2. 1199 West Central Street

December 30, 2025

BETA Group, Inc. (BETA) has reviewed revised documents and plans for the project entitled ***Garelick Farms Flood Resiliency Improvements*** (the Project), located at ***1199 West Central Street*** (the Site) in Franklin, Massachusetts. This letter is provided to present BETA's findings, comments and recommendations.

FRANKLIN, MA
GARELICK FARMS
FLOODING RESILIENCY IMPROVEMENTS
PERMIT DRAWINGS
SEPTEMBER 2025
REVISED OCTOBER 2025
REVISED DECEMBER 2025
REVISED JANUARY 2026

G-003

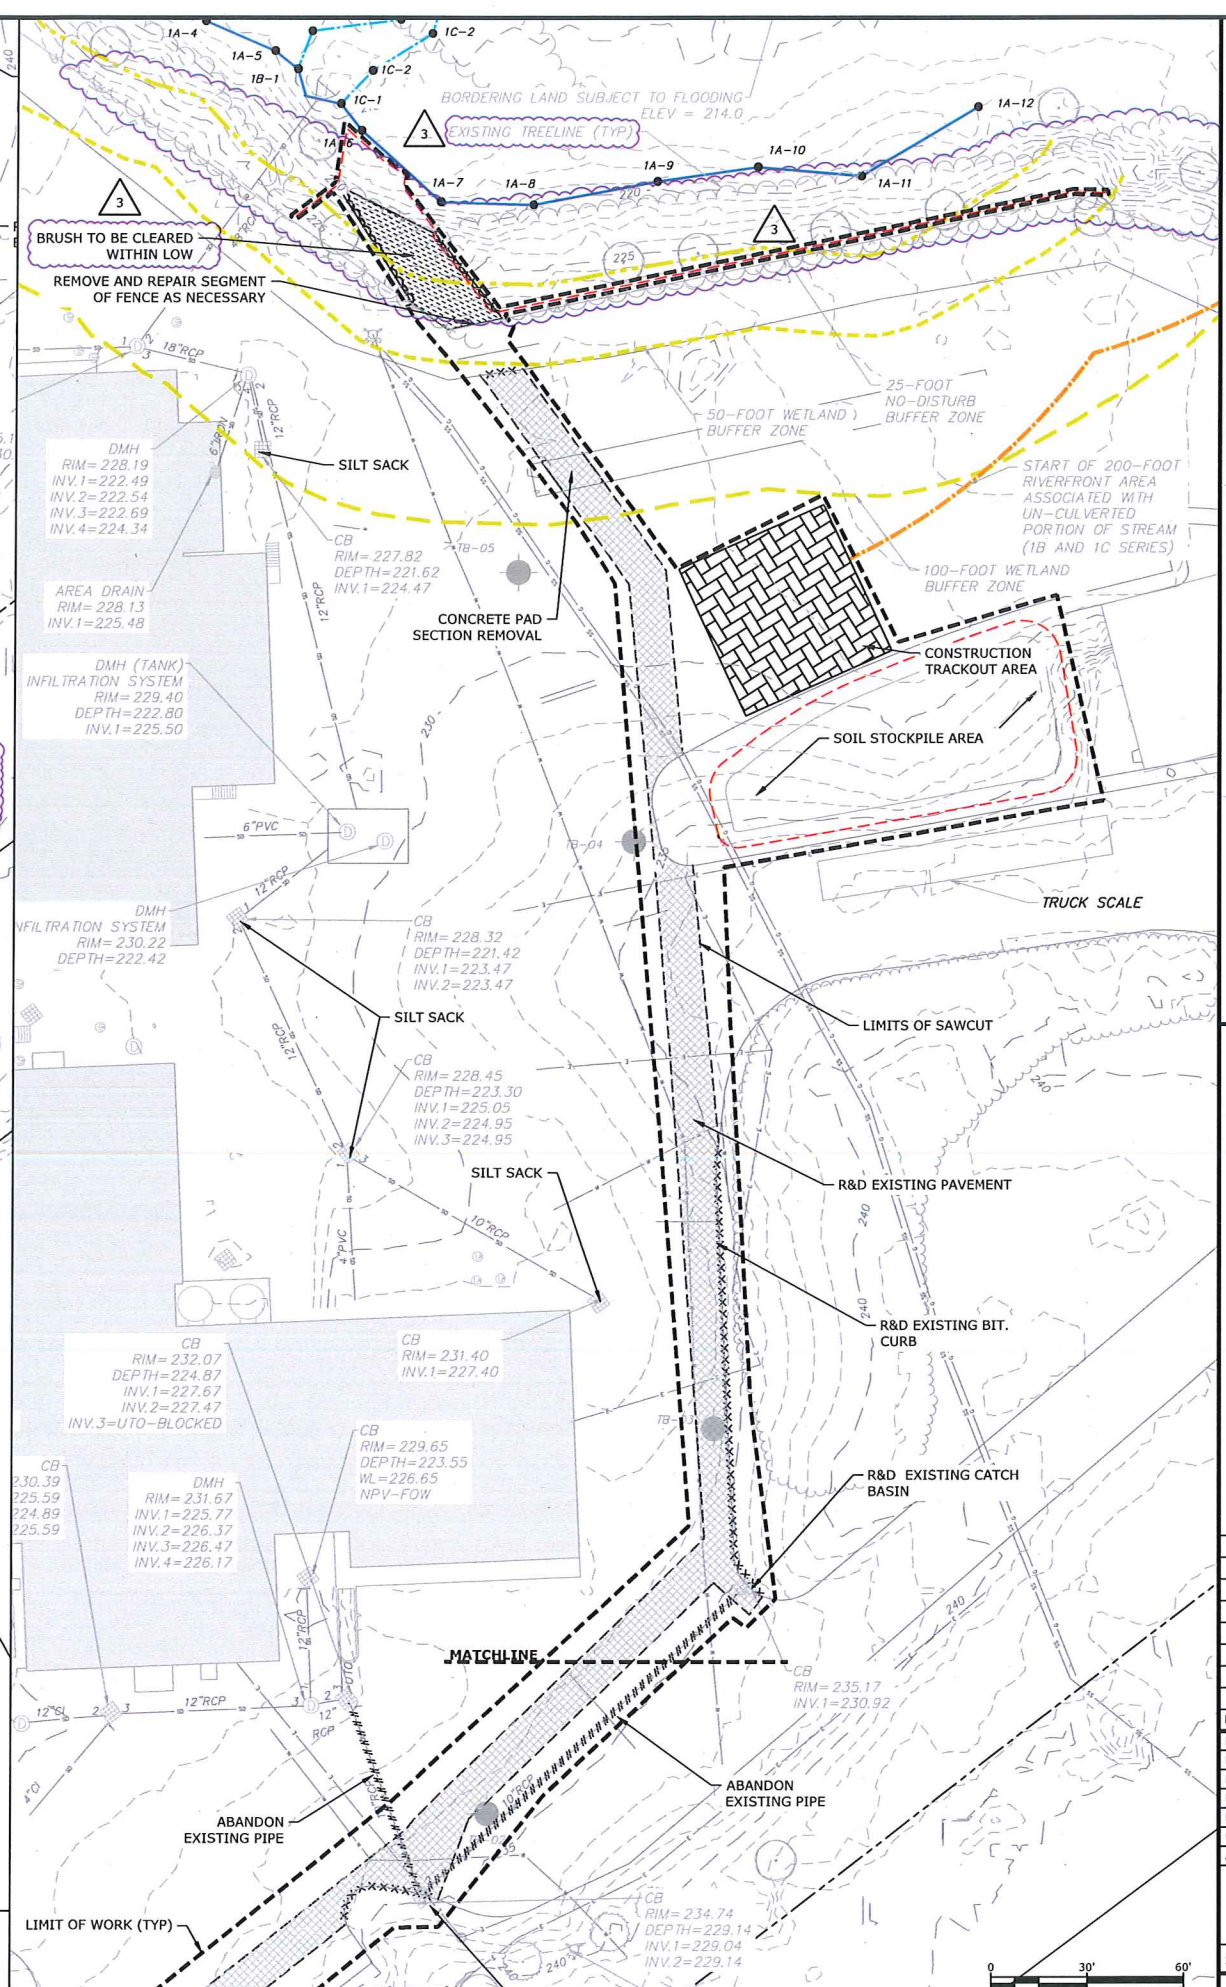
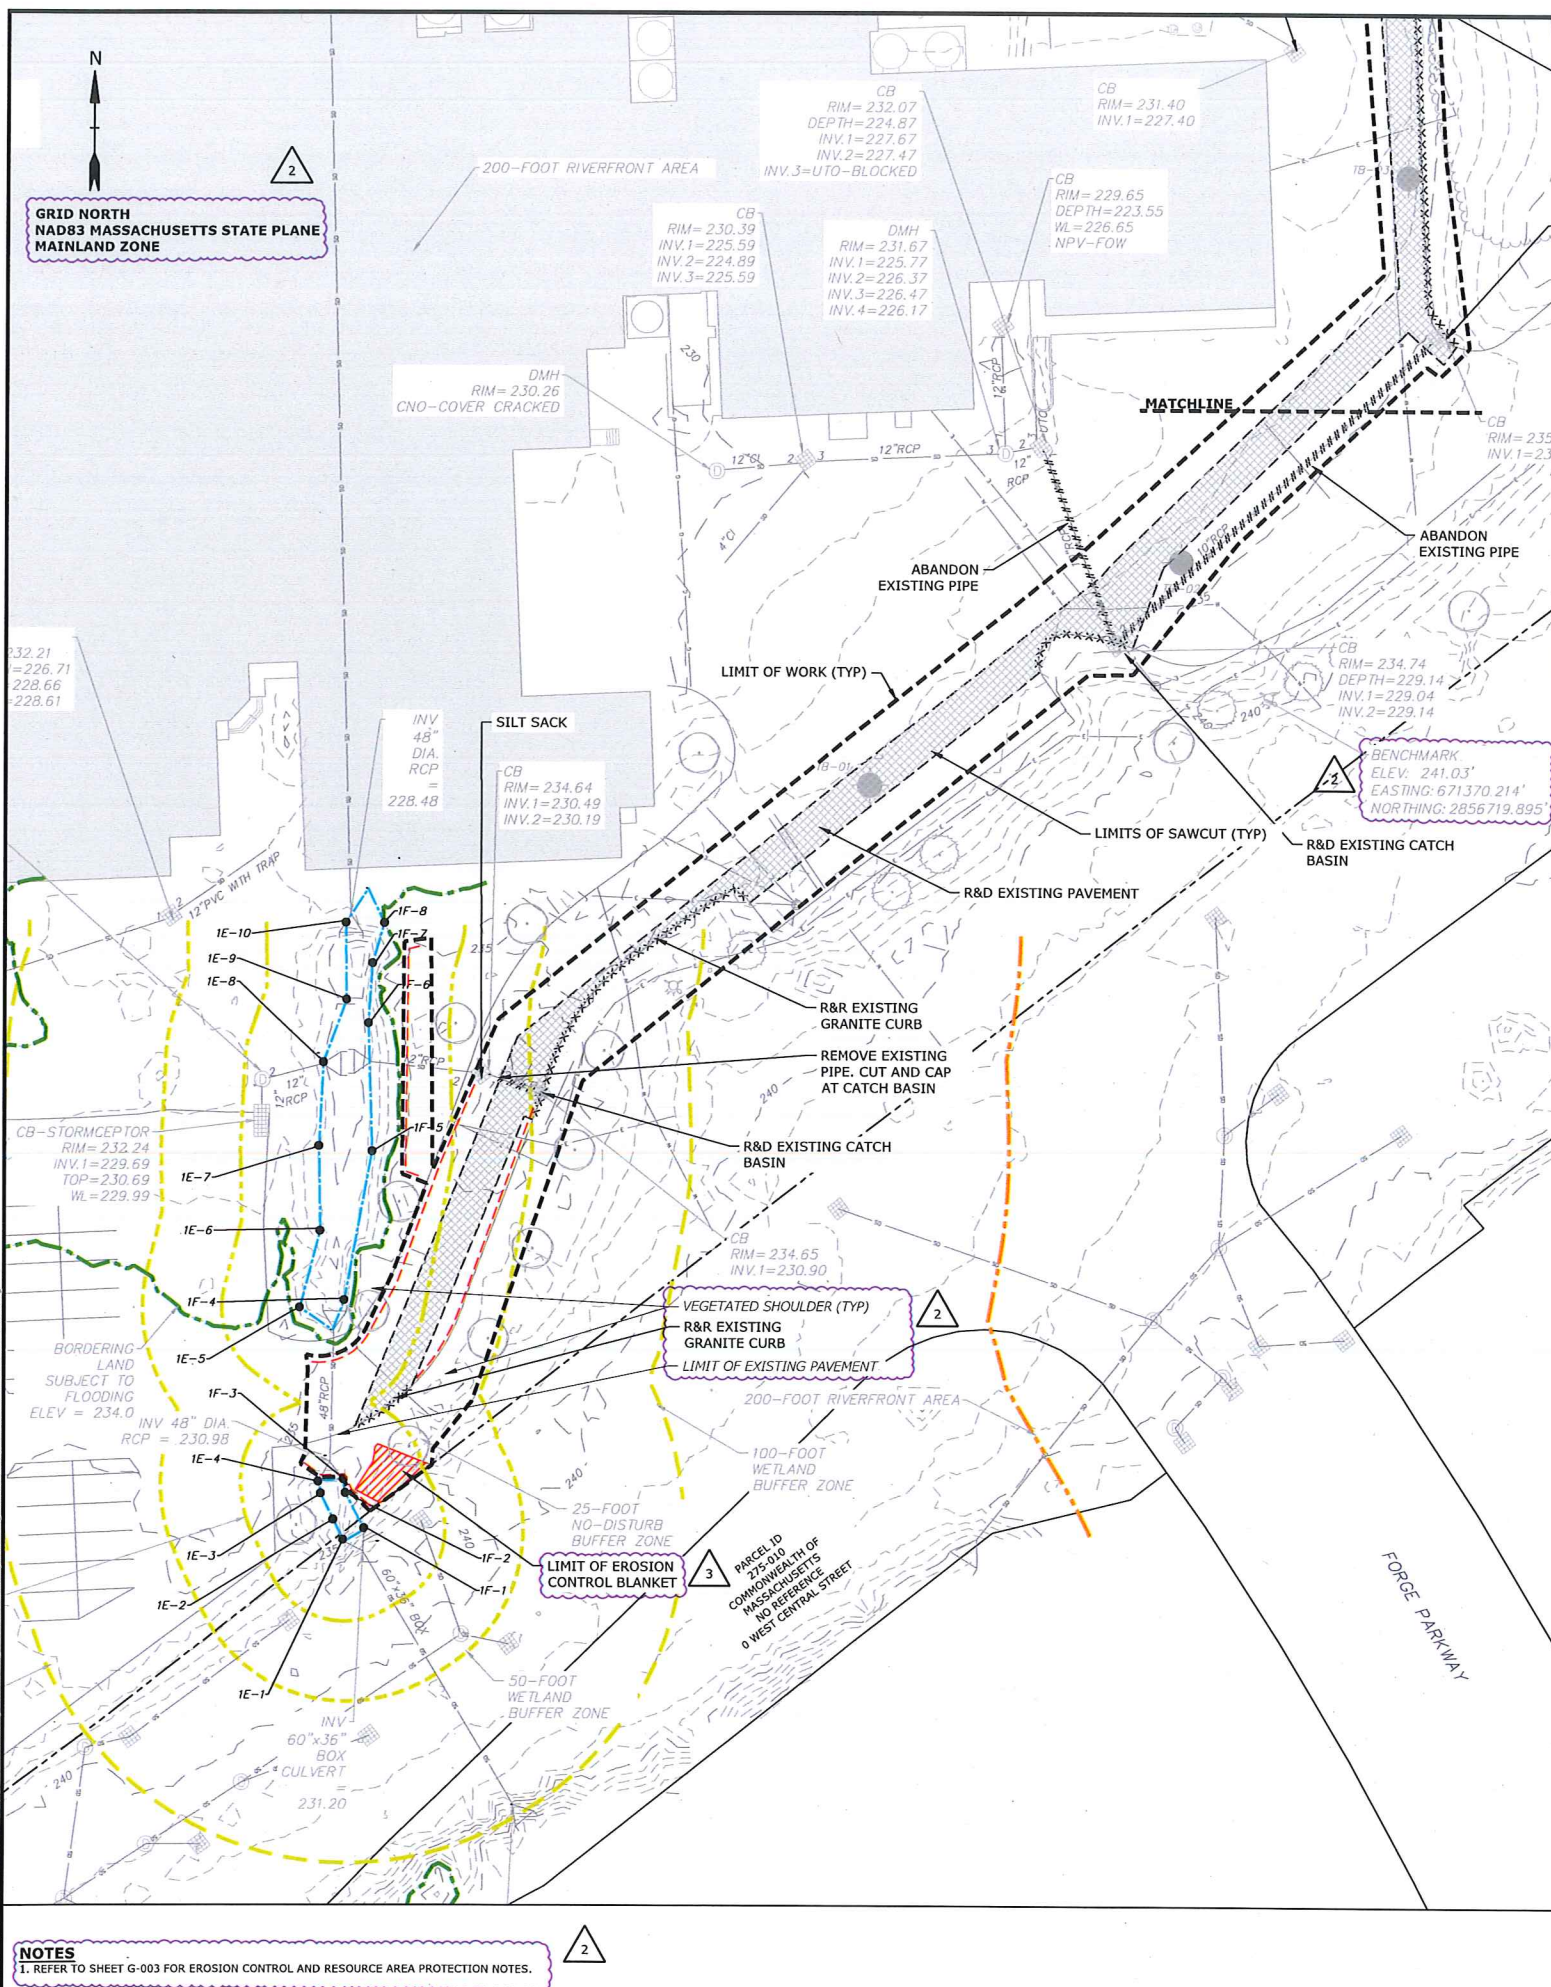
- c. A Construction Sequence with all proposed activities within Jurisdictional Areas should be provided on the plans per Bylaw Regulations Section 7.18.1.14.

- W16. The Applicant should provide the Construction Sequence on the plans per Bylaw Section 7.15.

TB: This information has been added to the plan set on sheet G-003.

TB: This information has been added to the plan set on sheet G-003.
